application

PROPERTY: 1417 NW 20TH AVE. PORTLAND, OREGON
RE: APPLICATION FOR DESIGN ADVICE REQUEST
SUBMITTED: AUGUST 20, 2015

DAR 01 comments | challenges

park edge | open space

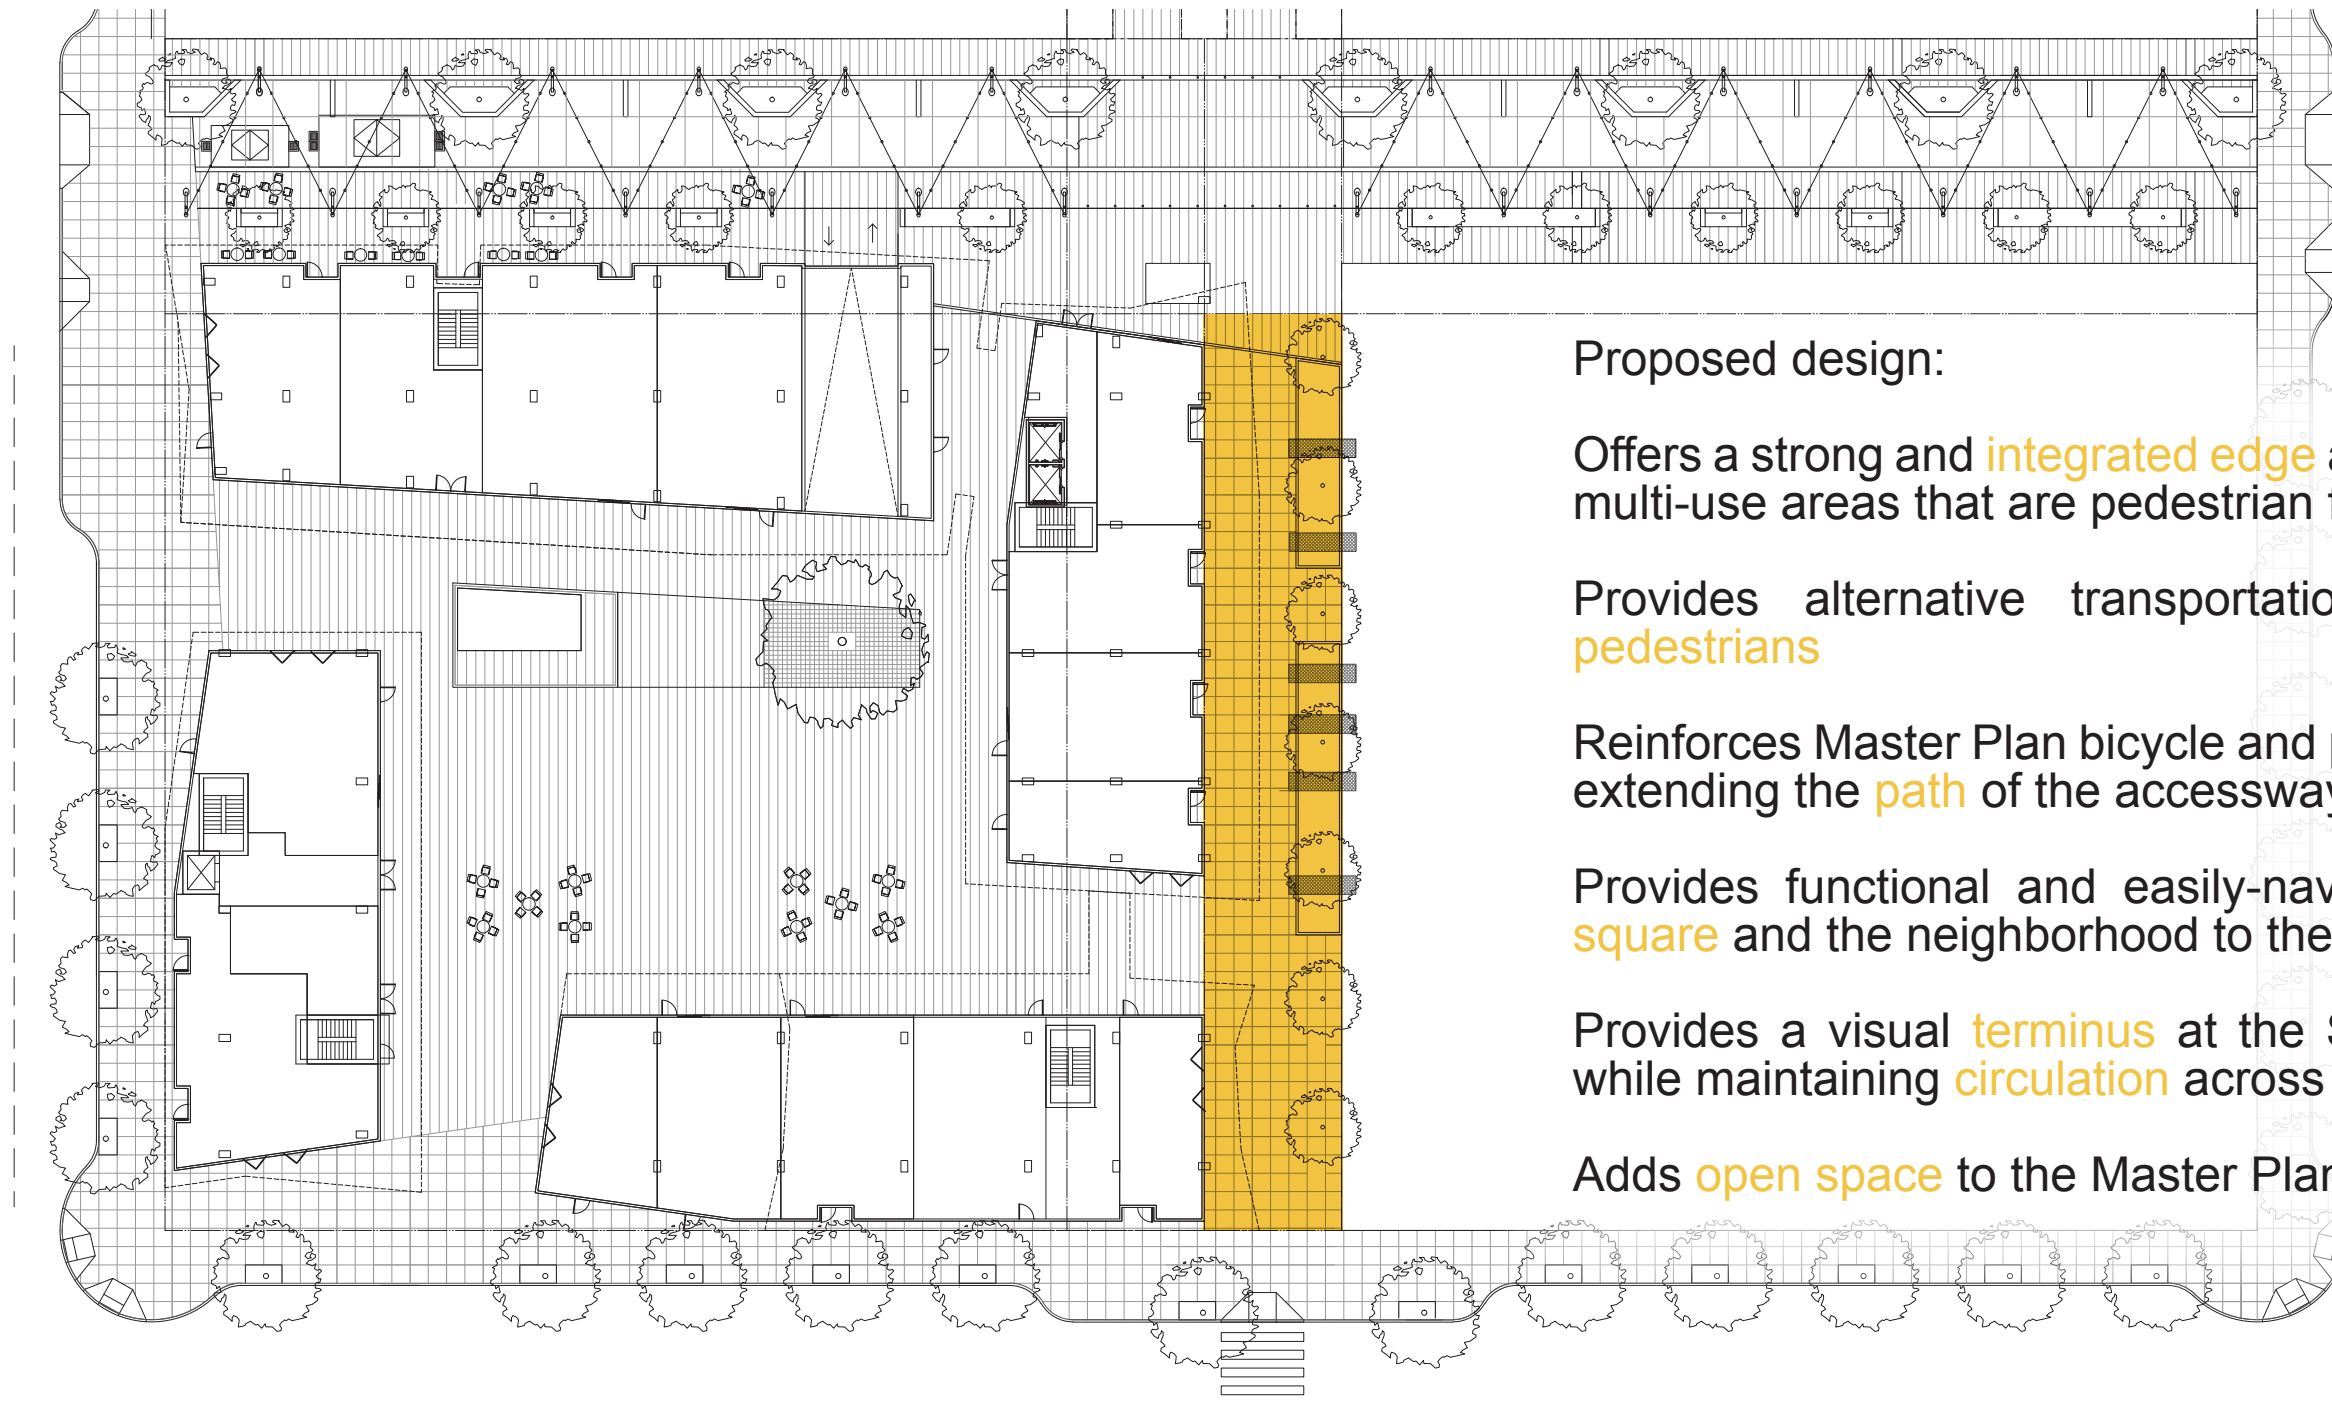
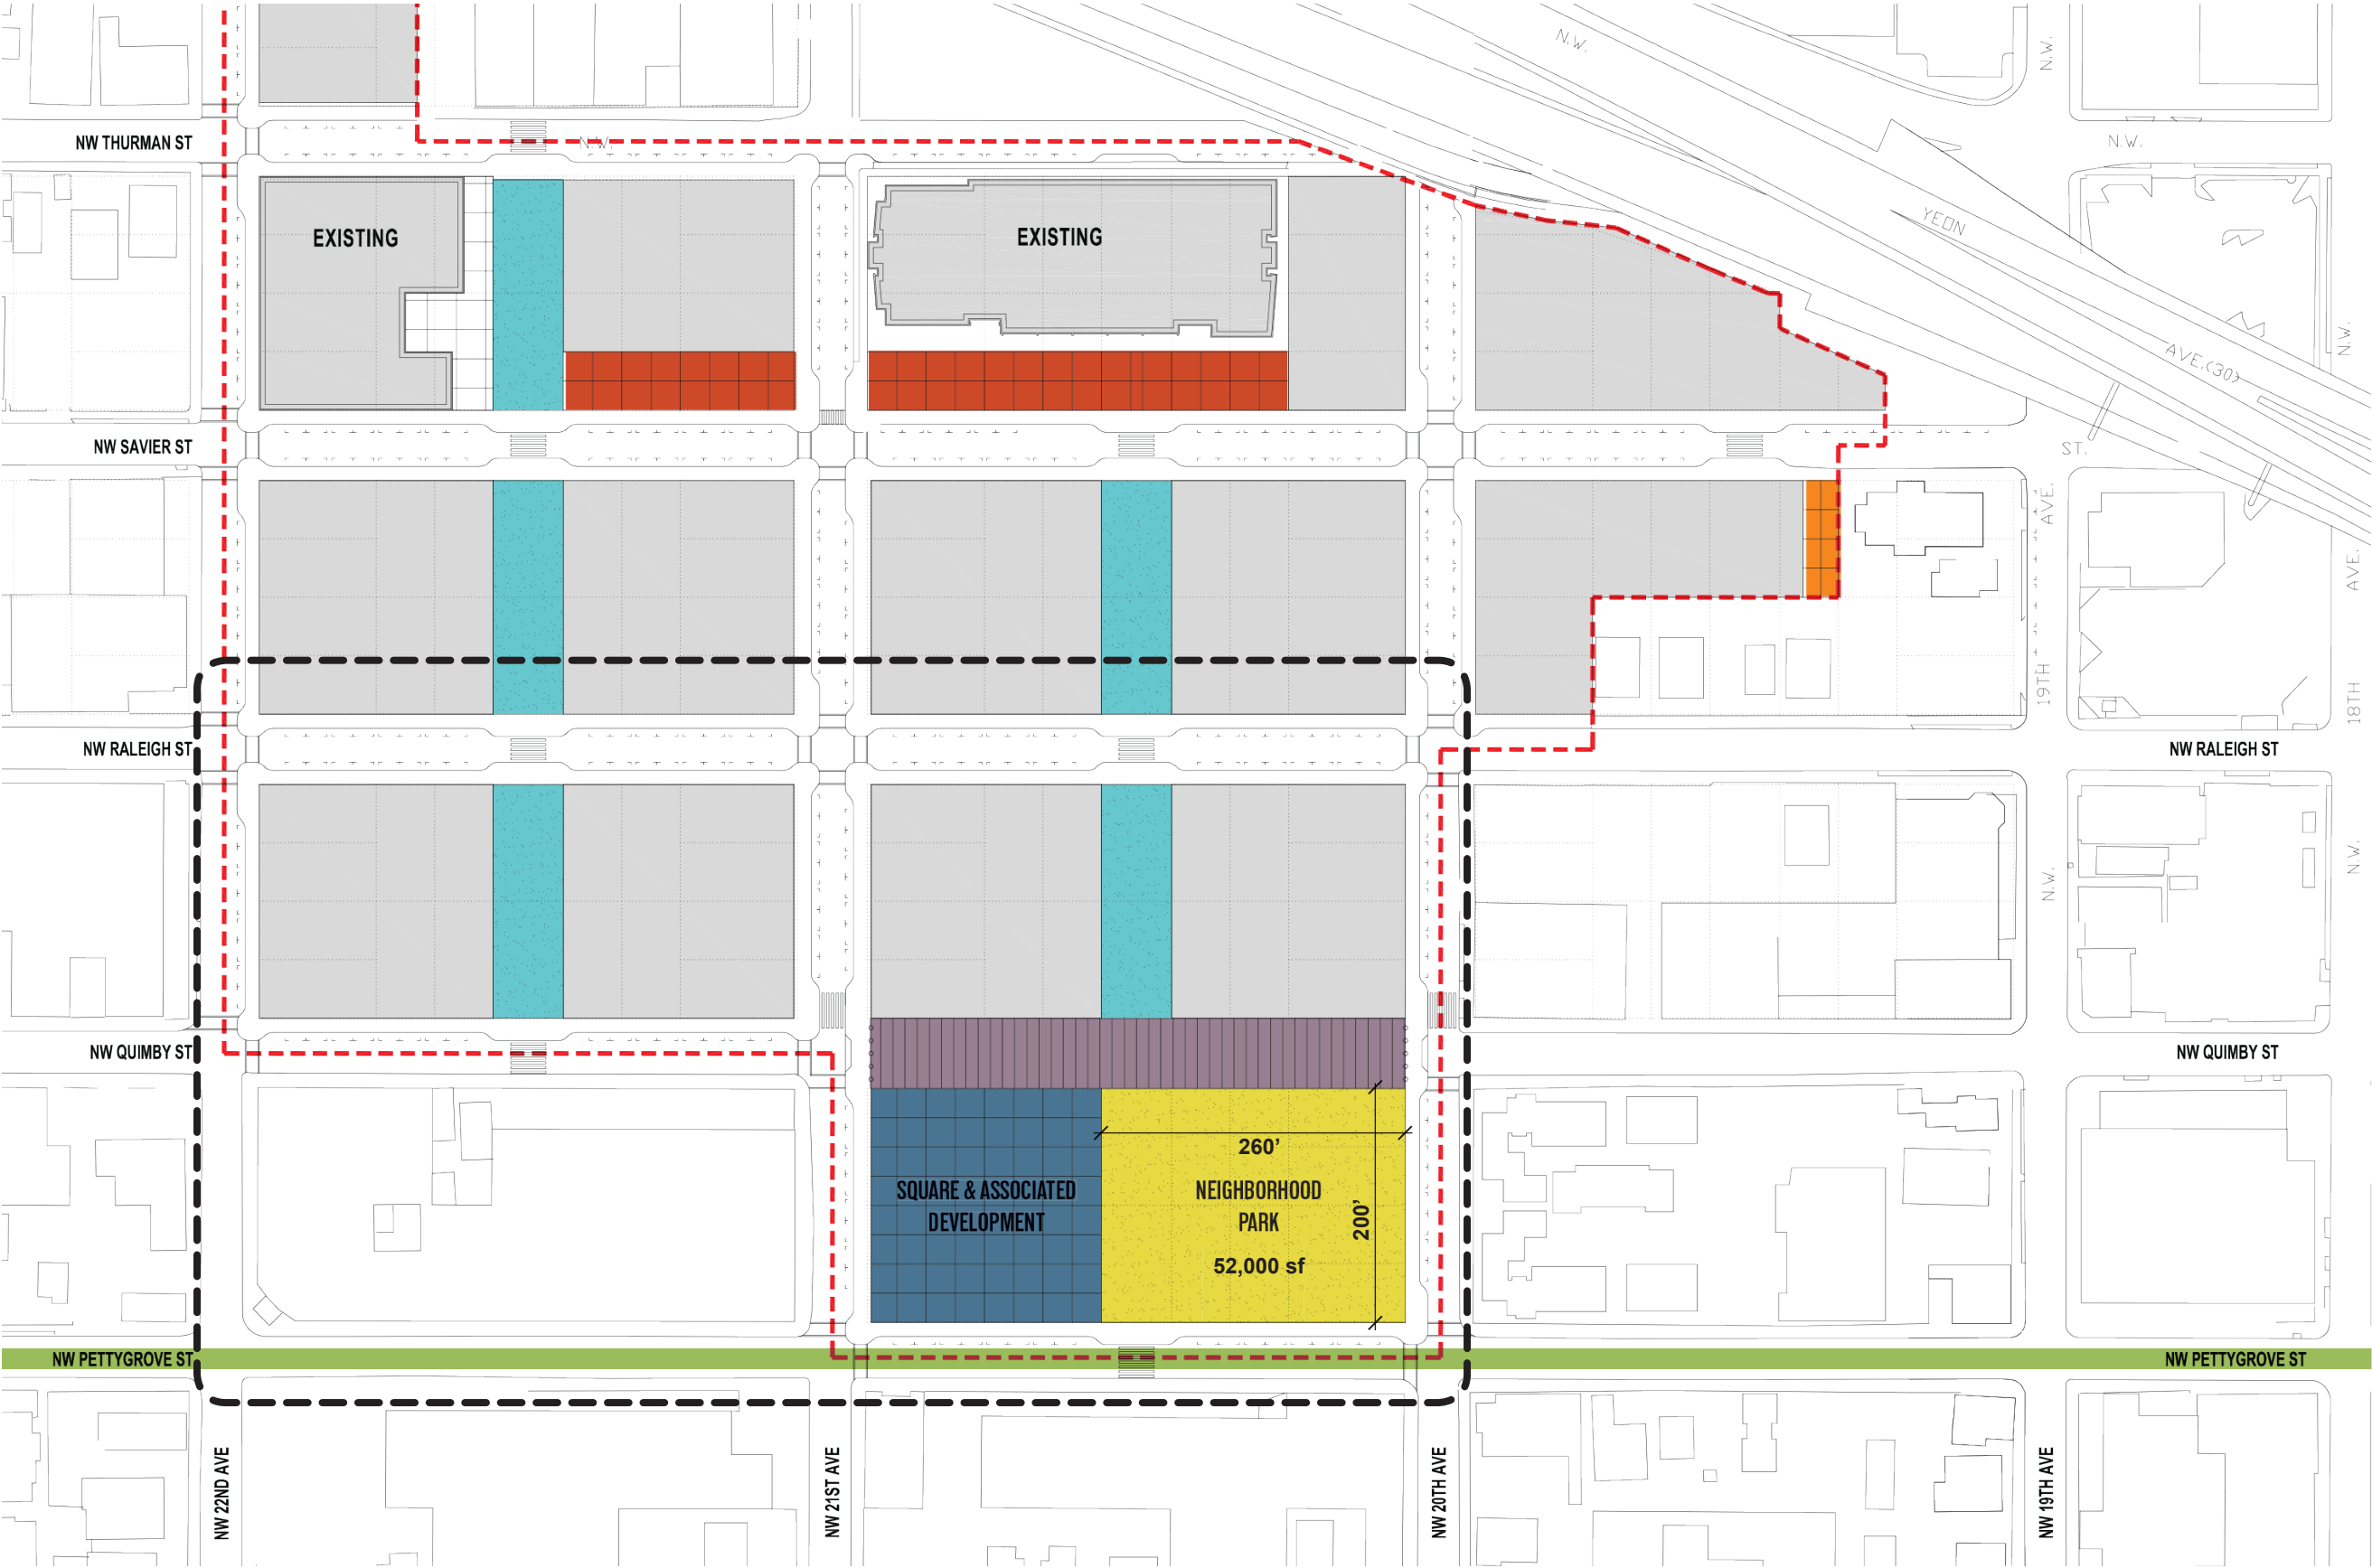
1. Move eastern buildings to the west, creating a meaningful interface with the park and clear path along the park edge while maintaining the spirit and activity of the Square.

Proposed design:

Offers a strong and **integrated edge** along the neighborhood park with multi-use areas that are pedestrian friendly

Provides alternative transportation systems for **bicycles** and **pedestrians**

Reinforces Master Plan bicycle and pedestrian **circulation** patterns by extending the **path** of the accessway to NW Pettygrove

Provides functional and easily-navigable **access** to the **park**, the **square** and the neighborhood to the south

Provides a visual **terminus** at the Southern end of the accessway while maintaining **circulation** across the site

Adds **open space** to the Master Plan at the Square **forecourts**

square design

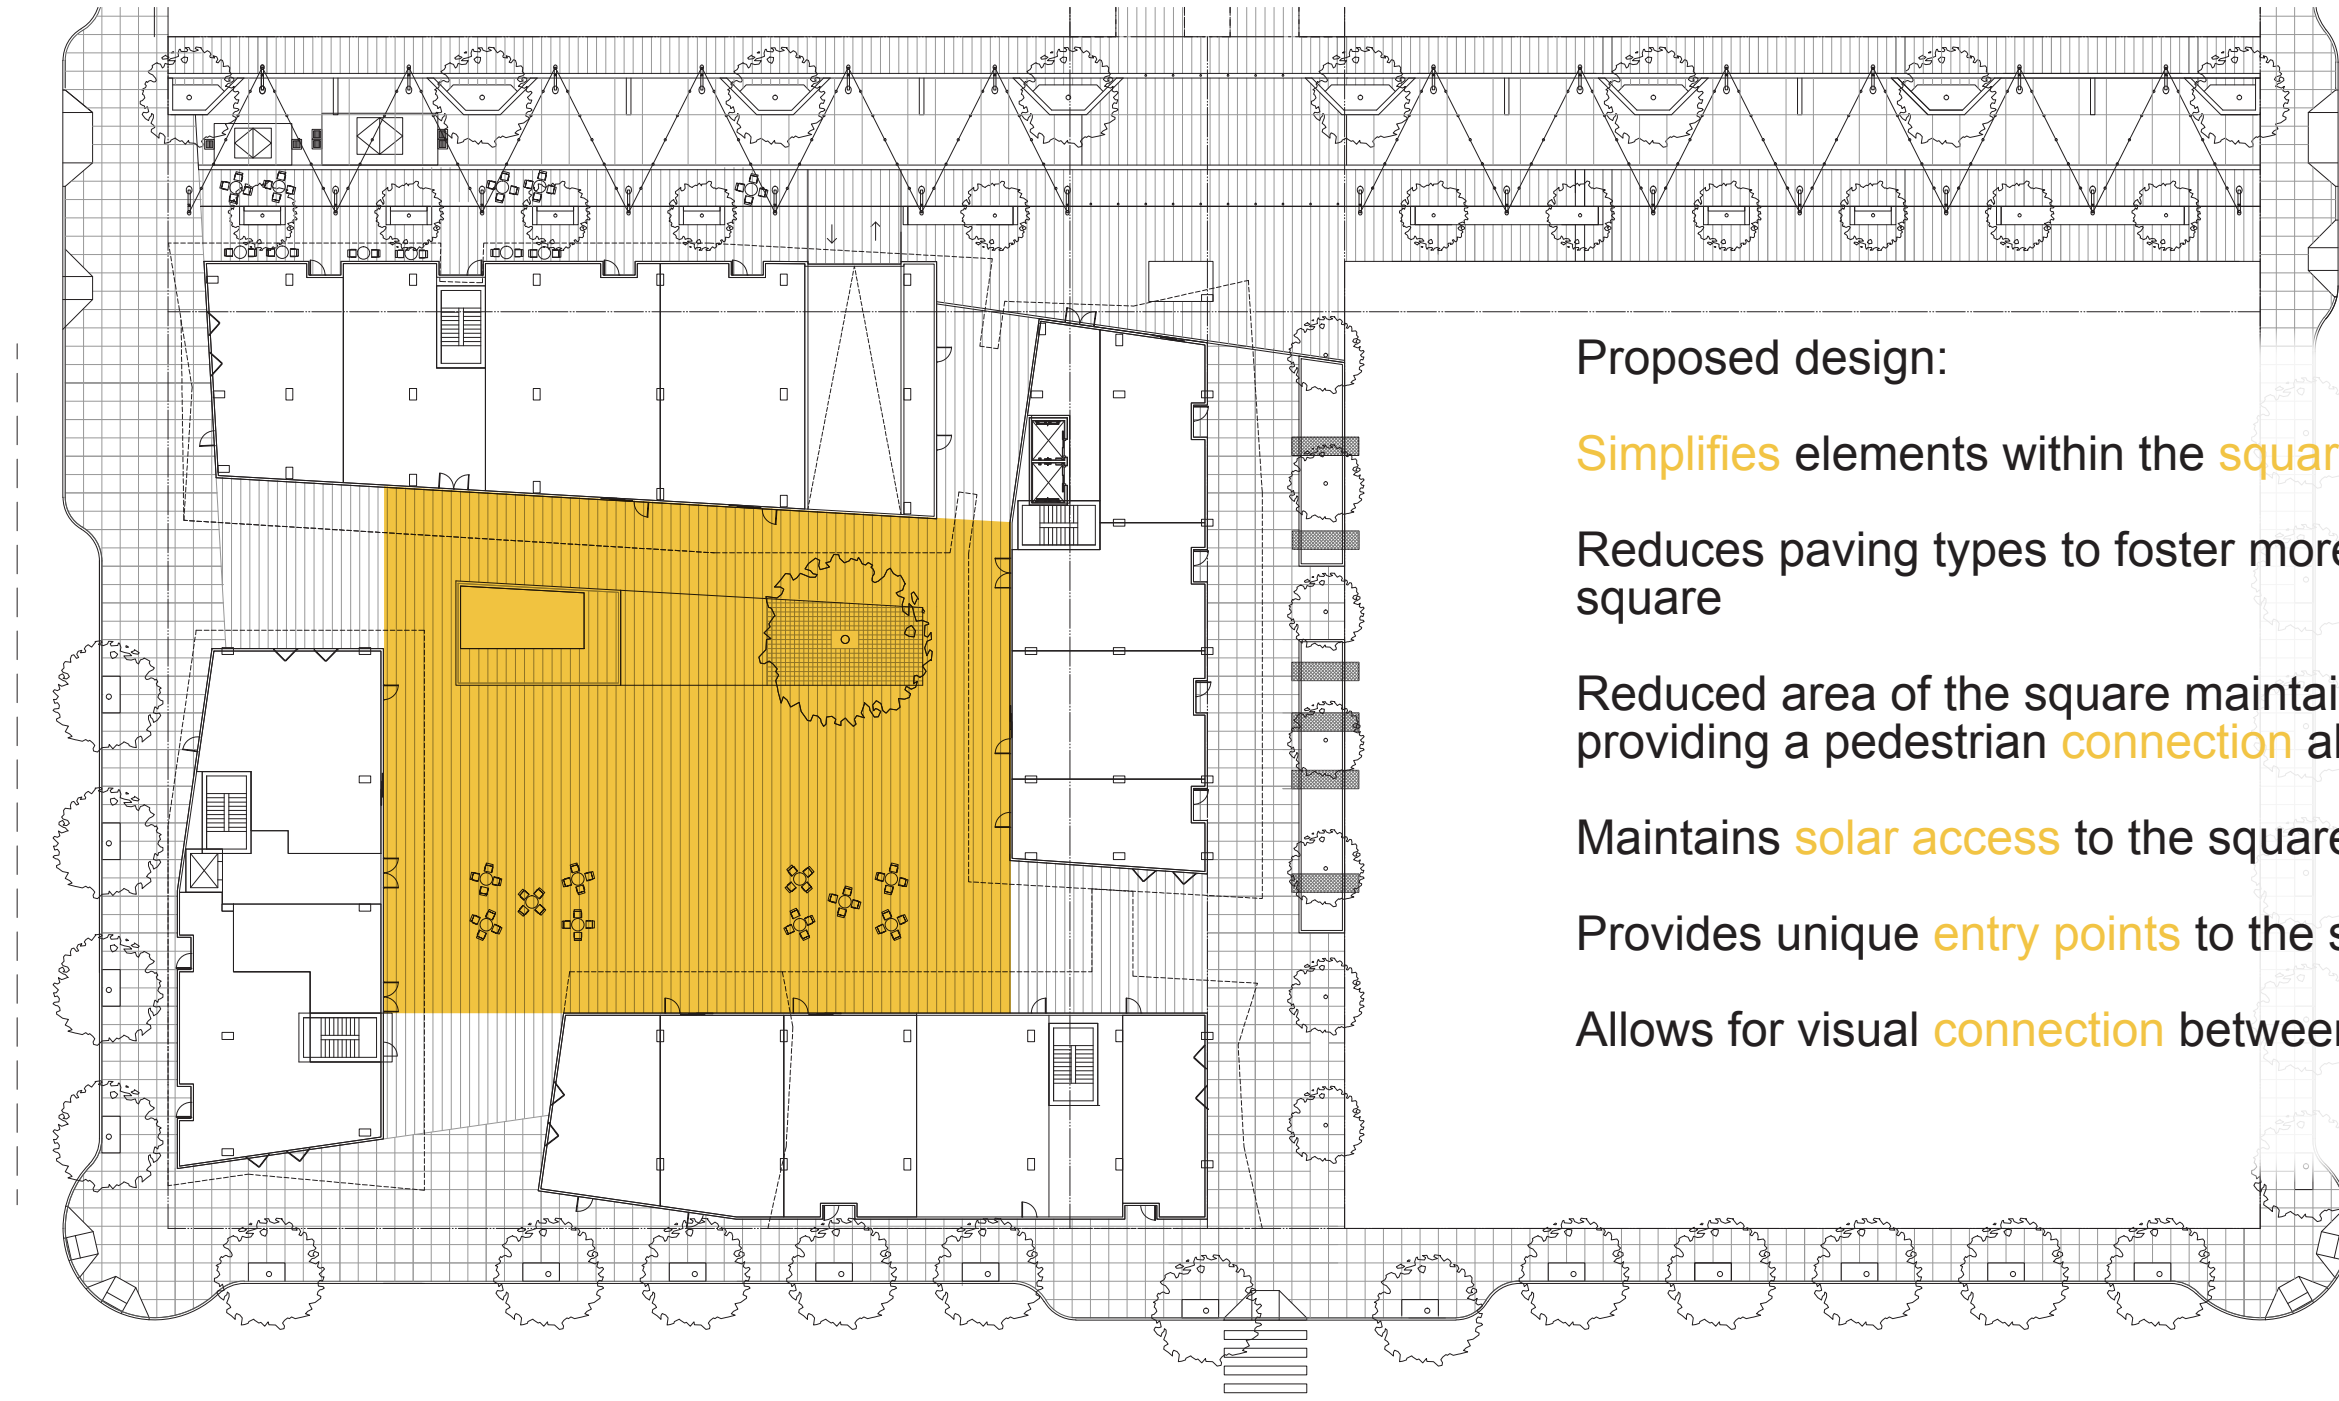
2. Simplify the Square materials and landscape design to provide a versatile public space that is active throughout the day.

Proposed design:

Simplifies elements within the square

Reduces paving types to foster more freedom of use within the square

Reduced area of the square maintains four-sided enclosure while providing a pedestrian connection along the park edge

Maintains solar access to the square

Provides unique entry points to the square on all four sides

Allows for visual connection between 21st Avenue and the park
